Interactive comment on “Sensitivity of Hydrologic and Geologic Parameters on Recharge Processes in a Highly-Heterogeneous, Semi-Confined Aquifer System” by Stephen R. Maples et al.

Stephen R. Maples et al.

Received and published: 25 November 2019

Fig. 1.

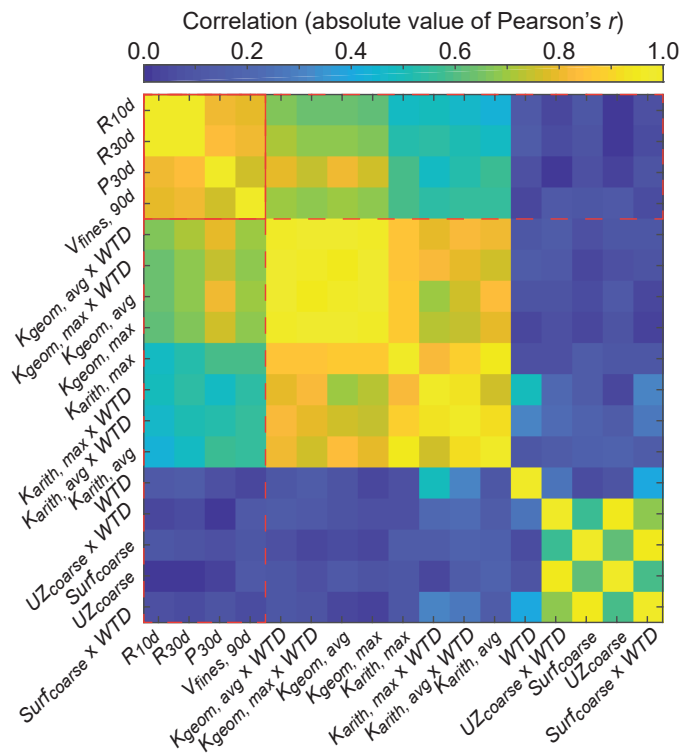
COMMENT: “Fig.1 and Fig.3 Please report the original publication source of the figure.” RESPONSE: We have reported the original source of Figure 1 (Maples et al., 2019), but Figure 3 is unique to this publication, and thus does not have a publication source, so the Figure 3 caption was left as-is.
